# RECOMMENDED CHANGE ON ANY PRE-2007 VEHICLE WITH A PENNTEX ALTERNATOR

Pre-2007  
PennTex Regulator  
Ground Connection  
(72 Inches Long)

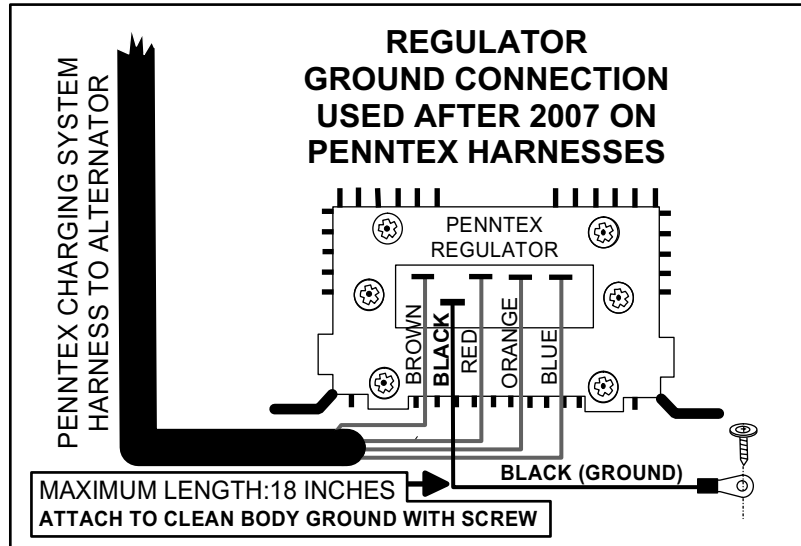
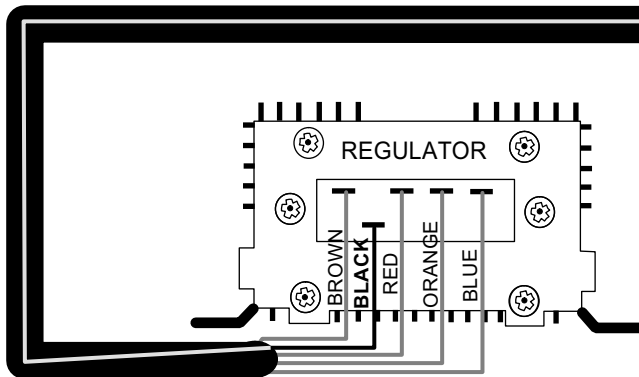
**OLD SIX-FOOT-LONG BLACK REGULATOR GROUND CONNECTION ON OR NEAR THE ALTERNATOR. REMOVE THIS CONNECTION AND CUT THE WIRE.**

In 2007 the Regulator ground wire was shortened from 72 inches to 18 inches. We recommend shortening the Regulator ground wire on all 2007 & earlier vehicles that have not been modified already. This can improve Regulator performance. Any new PennTex harness comes with the Ground wire already shortened to 18 inches.
